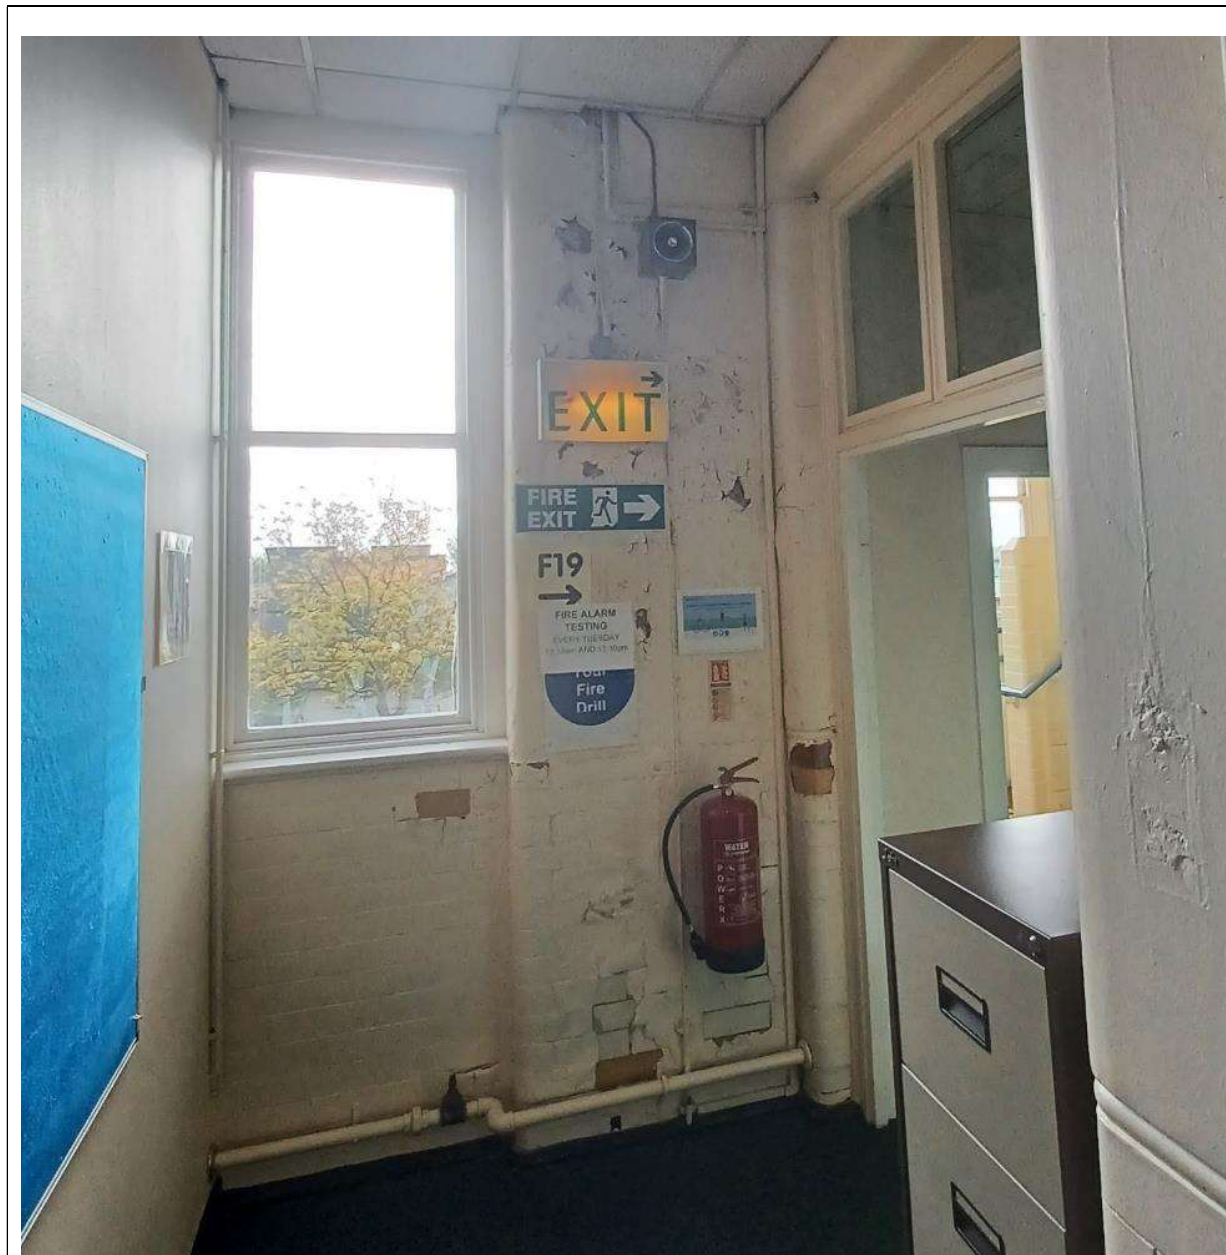
Photograph:	1	-	Exit sign – Surface mounted exit sign – no longer complies with BS 5499
-------------	---	---	---

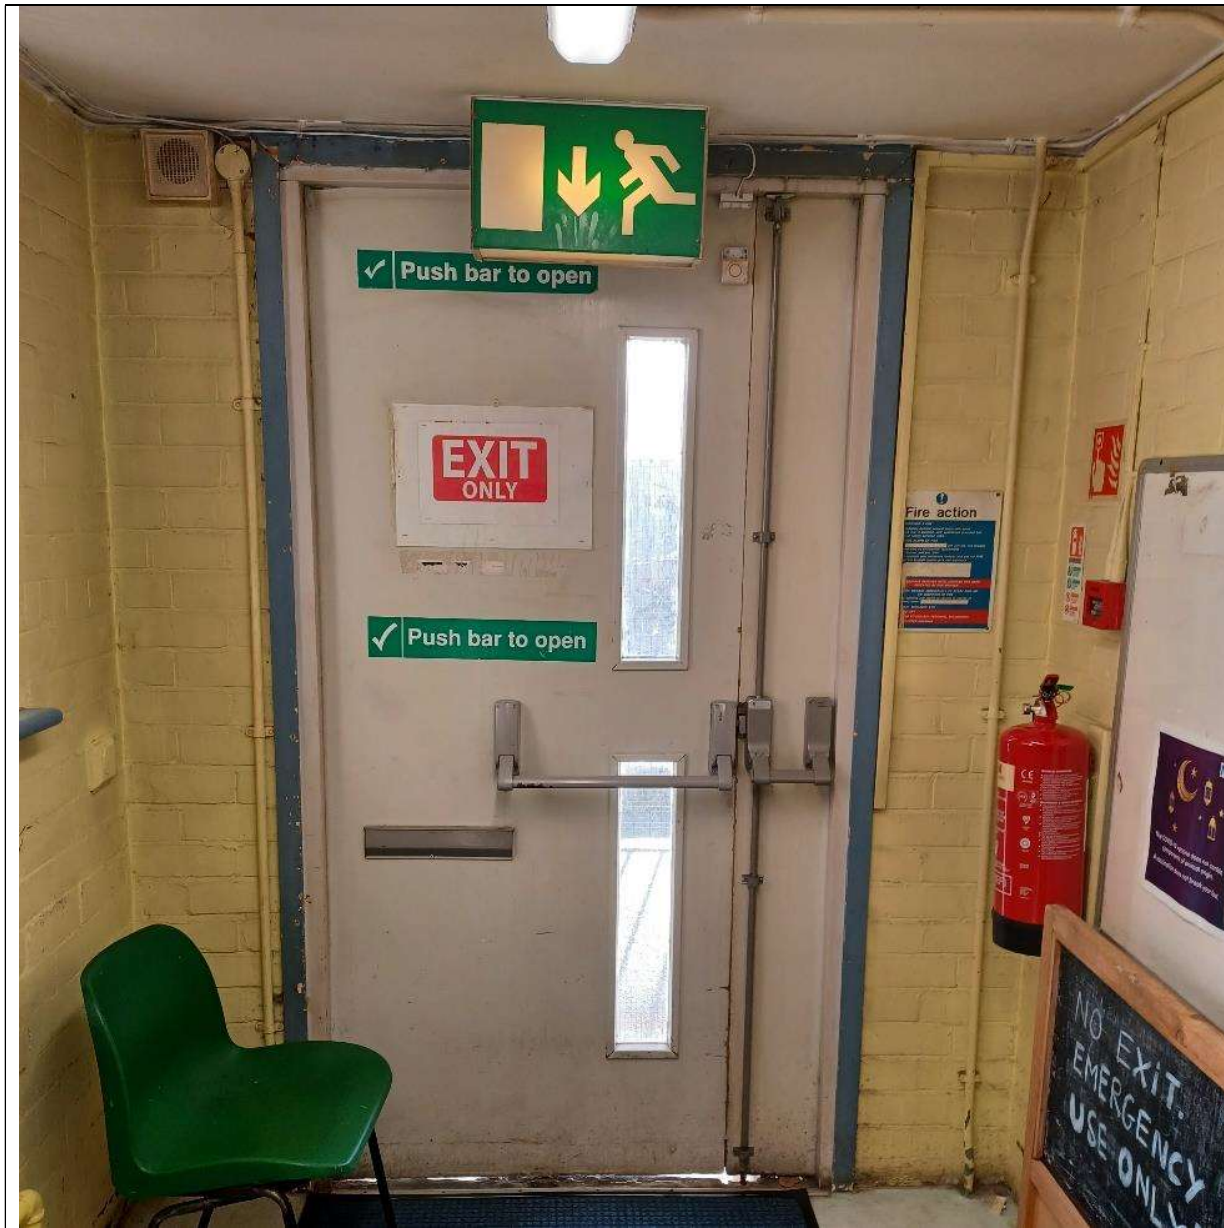
Photograph:	2	-	Ceiling mounted exit sign – does not comply with BS 5499
-------------	---	---	--

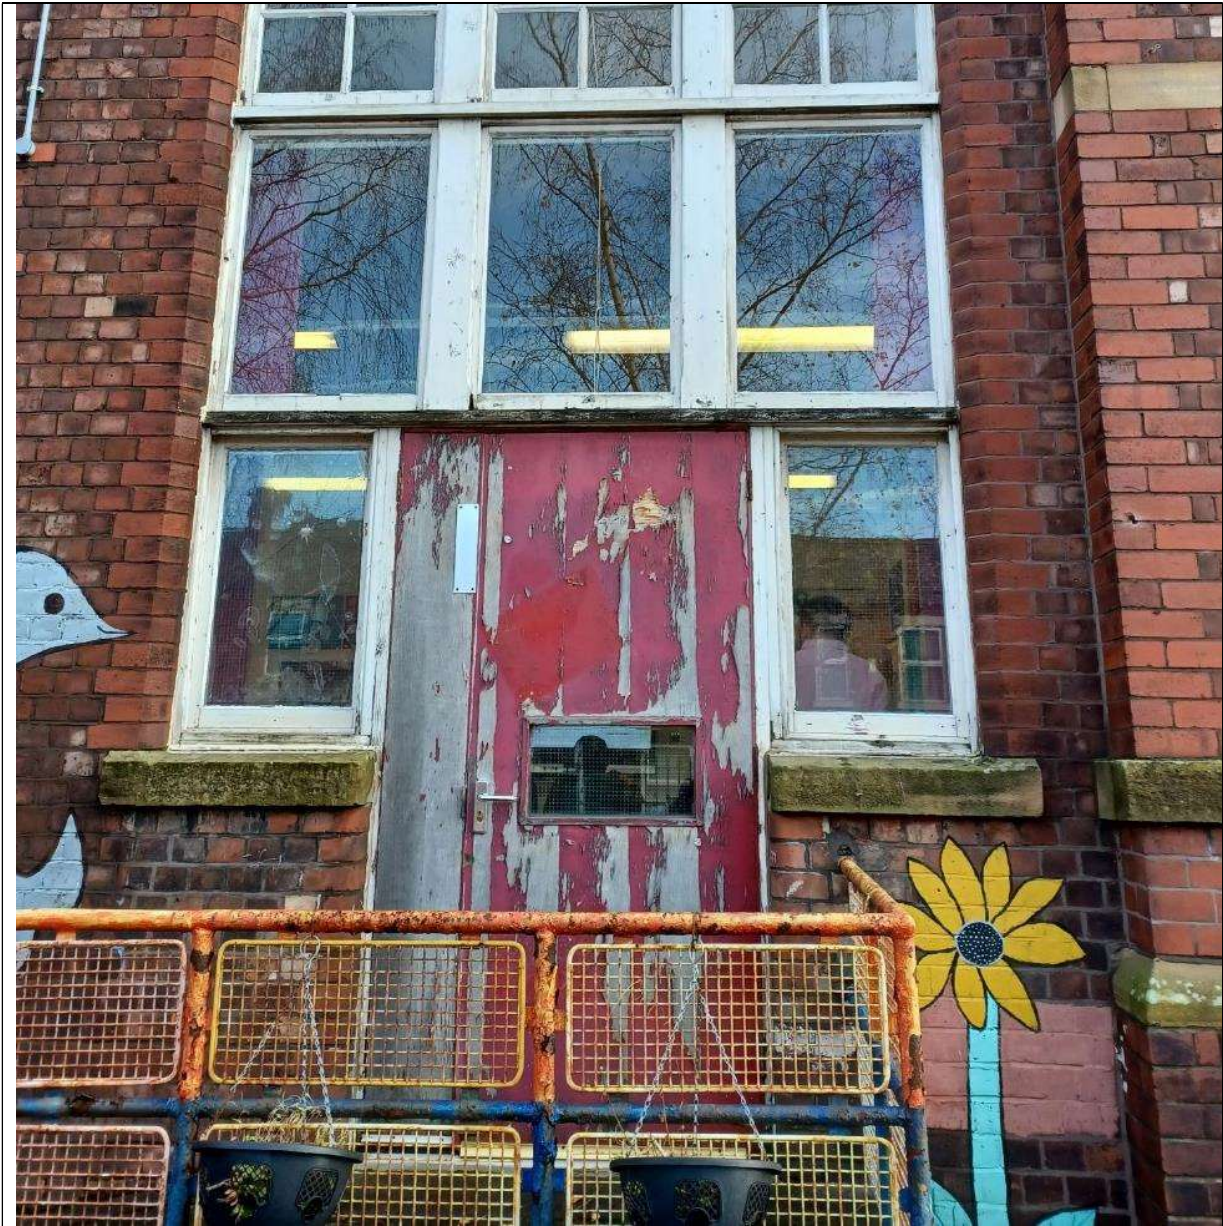
Photograph:	3	-	Final exit door with no external emergency lighting
-------------	---	---	---

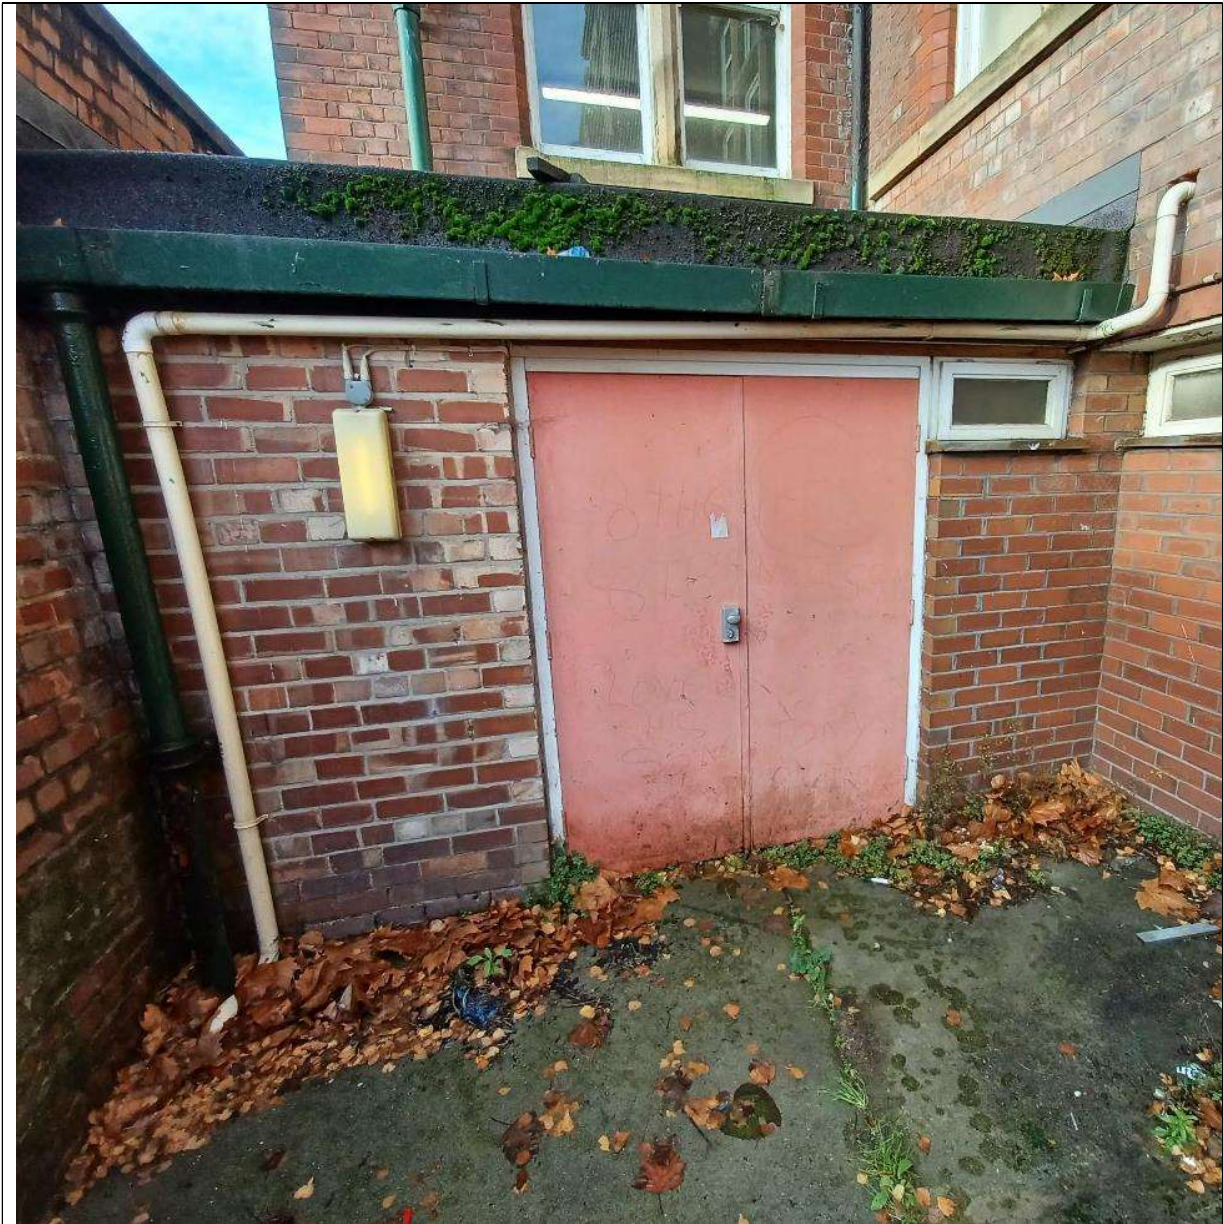
Photograph:	4	-	Final exit door with no exit sign
-------------	---	---	-----------------------------------
